**ADDITIONAL DETERMINISTIC EVALUATIONS
PERFORMED TO ASSESS SEISMIC MARGINS
OF THE DIABLO CANYON POWER PLANT
UNITS 1 AND 2**

Diablo Canyon Power Plant
Long Term Seismic Program

PREFACE

PG&E's response to the NRC Staff's April 1990 request for additional information regarding the Diablo Canyon Long Term Seismic Program deterministic evaluations is contained in this volume. The reply to the request is included in the responses to nine questions we have formulated to best describe the additional deterministic evaluations performed to augment the information contained in Chapters 7 and 8 of the Long Term Seismic Program Final Report. The NRC Staff's general request precedes Question DE 1.

Figure DE Q8-3

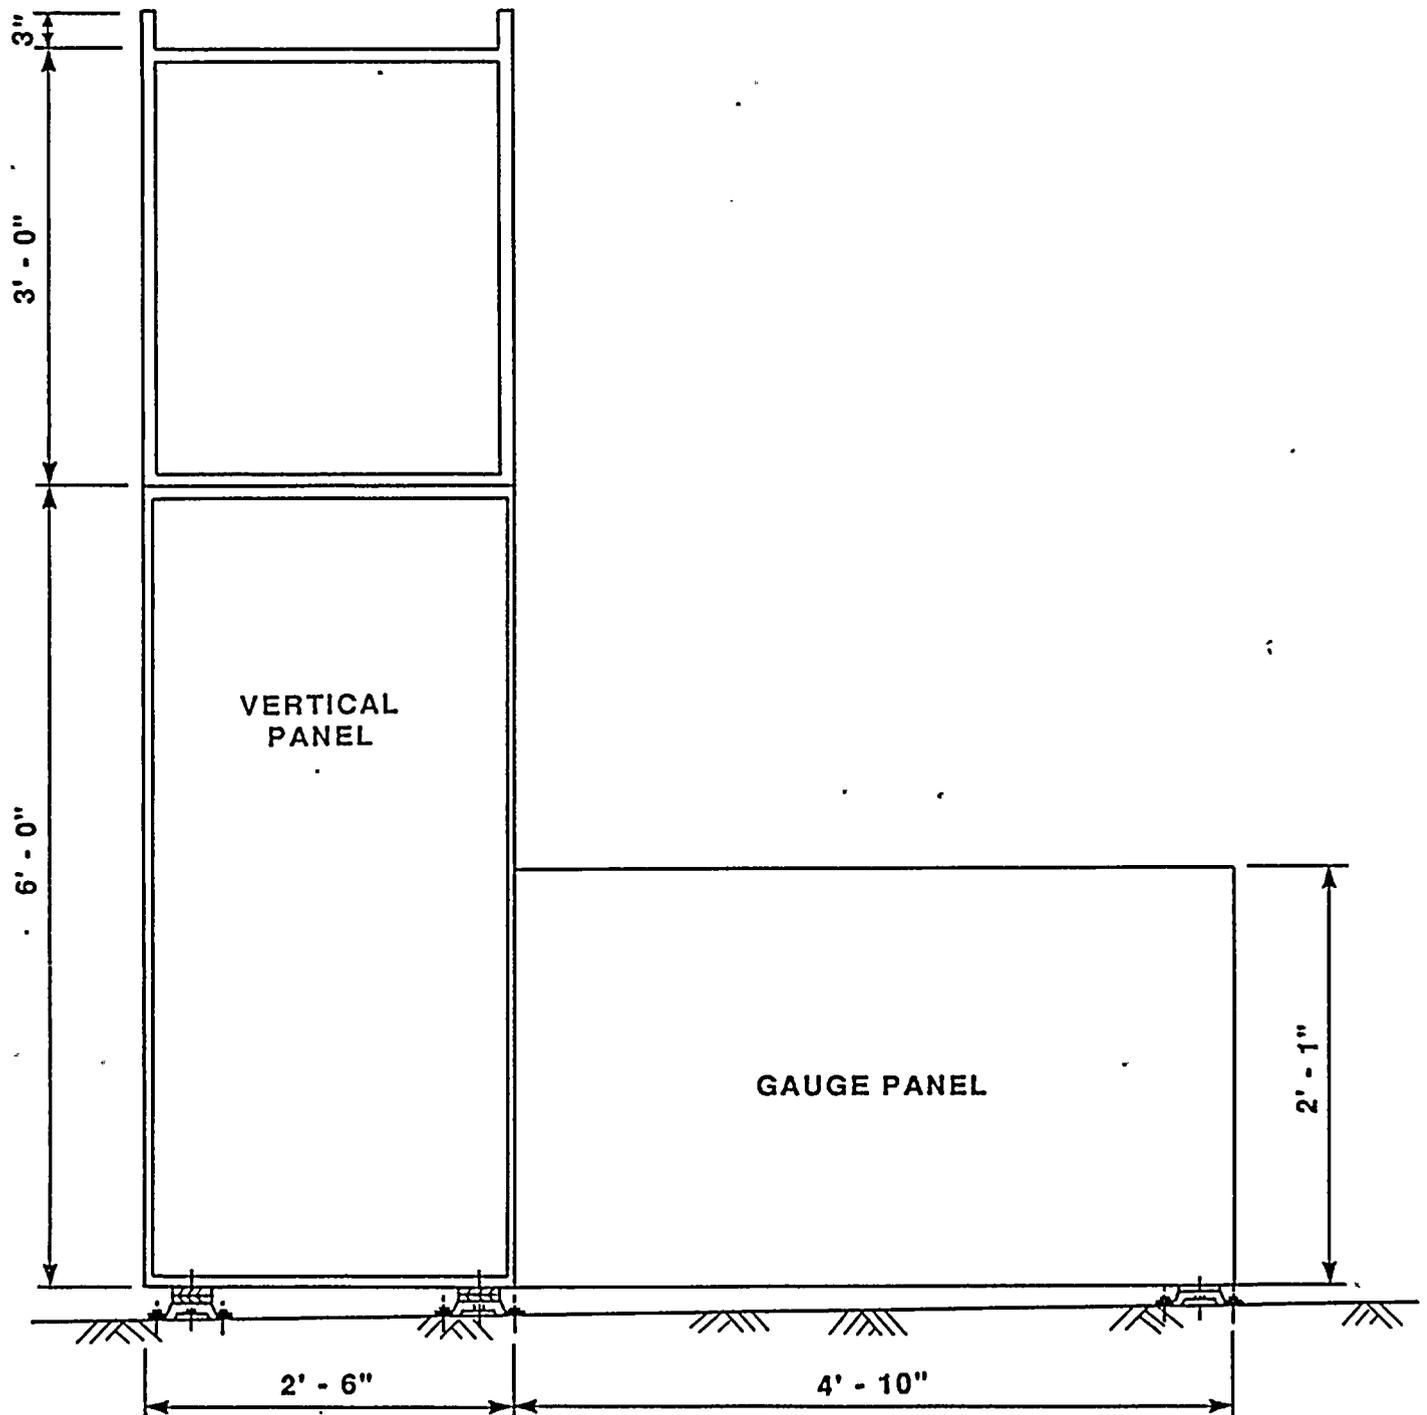
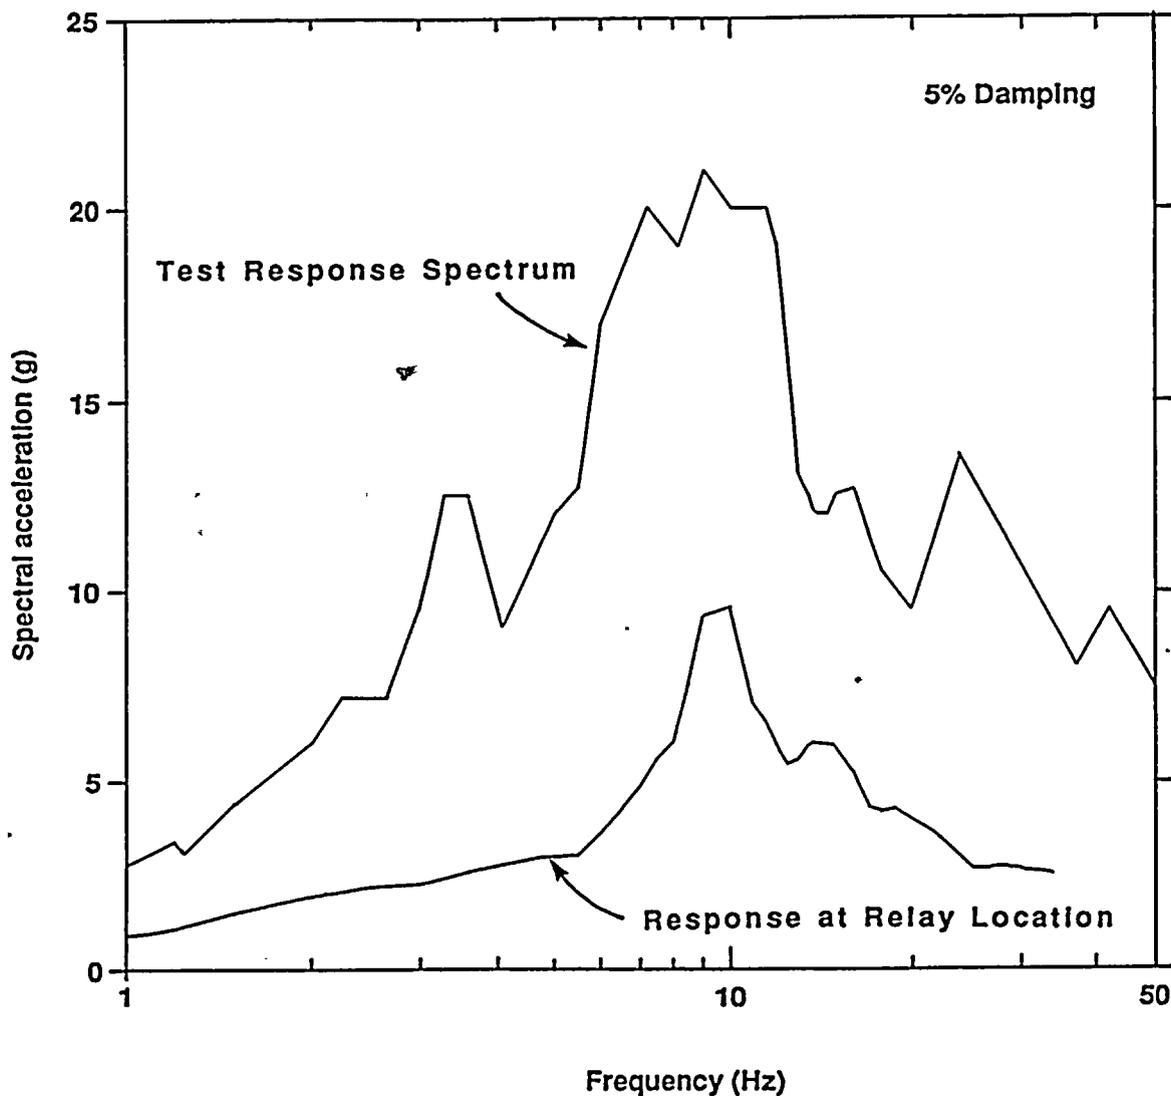
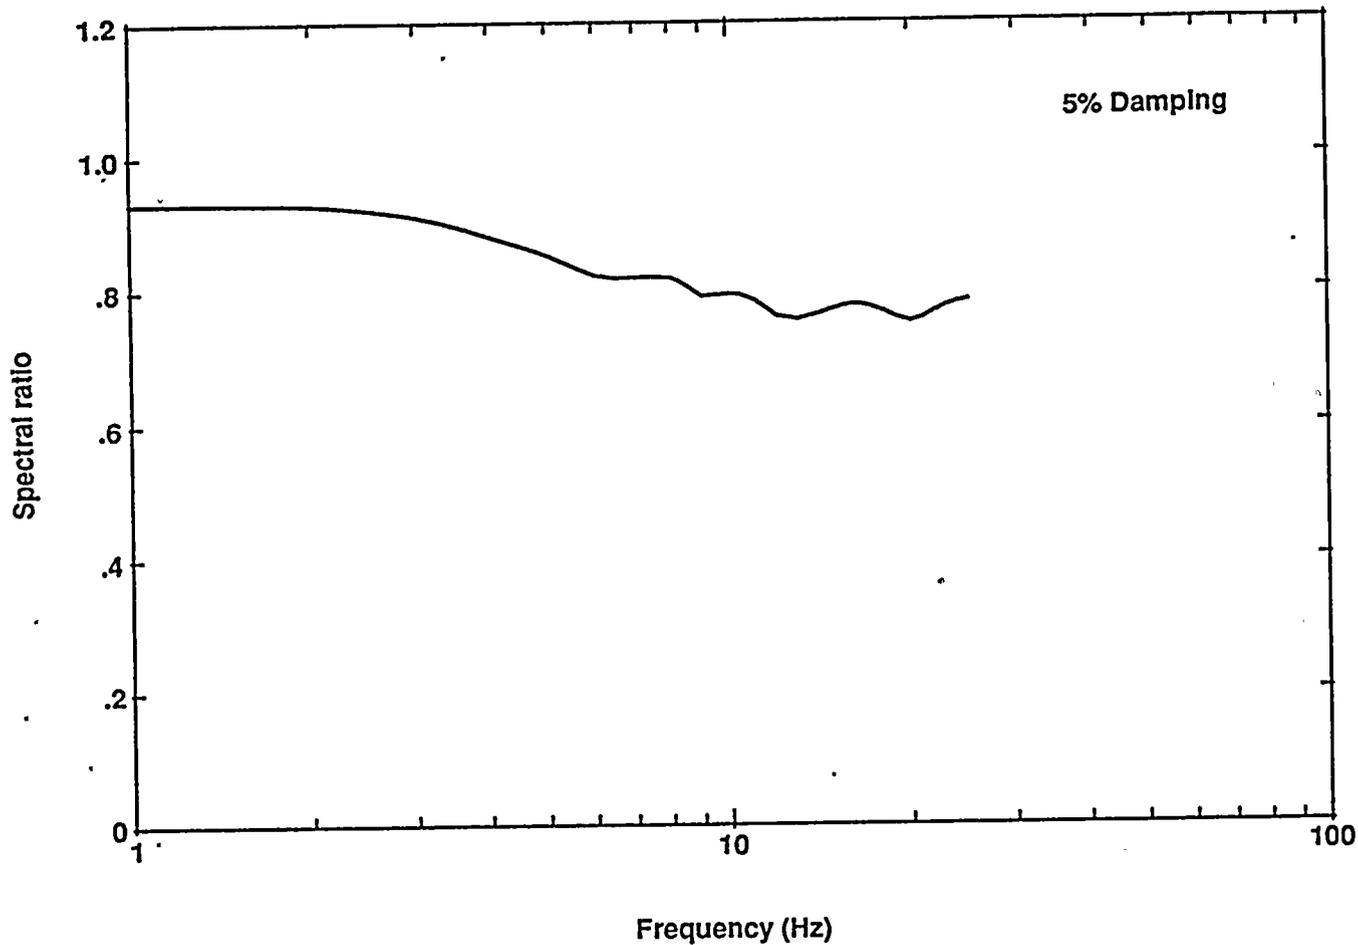
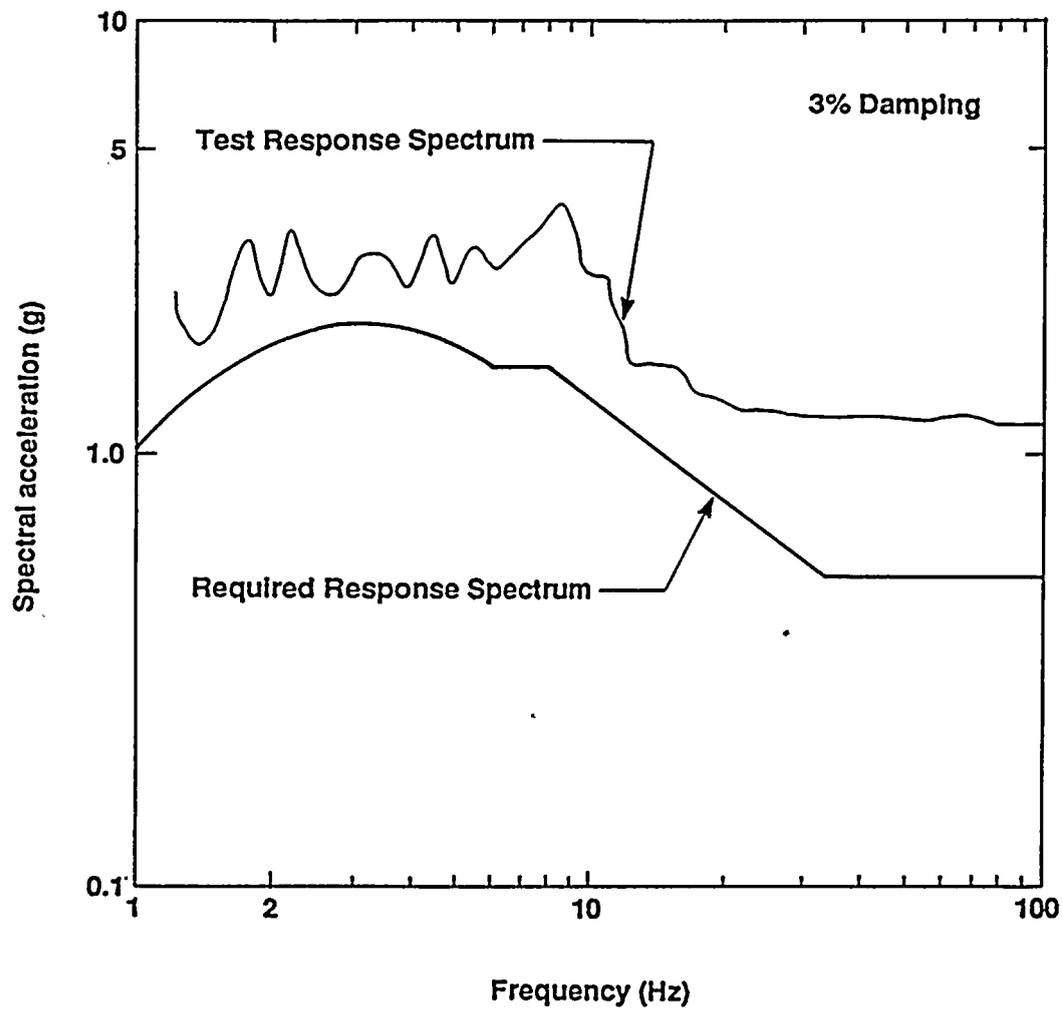
QUESTION DE 8

The diesel generator control panel is located at the basemat of the turbine building at elevation 85 feet. The panel consists of a vertical cabinet and an attached horizontal "side cabinet" (Gauge Panel) as shown in Figure DE Q8-3. The control panel is mounted on shock isolators to minimize the vibration induced by operation of the diesels. The panel is braced in the front-to-back direction by means of a framework fabricated from Unistrut members. The framework is attached to the top of the vertical cabinet and spans to the nearby structural wall.

In order to determine the demand acceleration at the relay location, the detailed model of the combined diesel generator control panel was analyzed using the longitudinal and transverse horizontal time-histories corresponding to the 84 percent ground response spectrum. The resulting average 5 percent damped horizontal response at a node point near the center of the relay subpanel was determined (Figure DE Q8-4) for the critical front-to-back response direction. Also shown in Figure DE Q8-4 is a 5 percent damped single axis, broad-frequency fragility test response spectrum (TRS) for these relays. The ratio of TRS to the required response spectrum (RRS) is lowest at about 15.0 hertz. Over a 20 percent frequency bandwidth centered on 15.0 hertz, the average TRS is 12.5 g and the average RRS is 5.6 g. Accounting for the effect of the ground motion incoherence factor of 0.8 (Figure DE Q8-5) in the front-to-back cabinet response, the demand horizontal spectral acceleration is:

The qualification test included only the vertical cabinet with a side-to-side frequency of 5.4 hertz. Thus, the structural elements of the control panel experienced accelerations consistent with the Test Response Spectrum (Figure DE Q8-6) at approximately 5.4 hertz. However, the addition of the Gauge Panel increases the side-to-side frequency to approximately 10 hertz. Therefore, the demand accelerations must be evaluated at the fundamental frequency of the combined cabinet. Since the 5.4 hertz frequency of the tested configuration was determined by test, the uncertainty in the actual vertical cabinet-only frequency is reduced and is characterized by a ± 10 percent variation. In contrast, the combined cabinet fundamental frequency was determined by finite element model analysis for which a ± 15 percent variation should be used.

The acceleration capacity of the diesel generator control panel was evaluated from the test response spectra over the 4.9 to 5.9 hertz range and equated to the demand acceleration evaluated at 8.5 hertz.
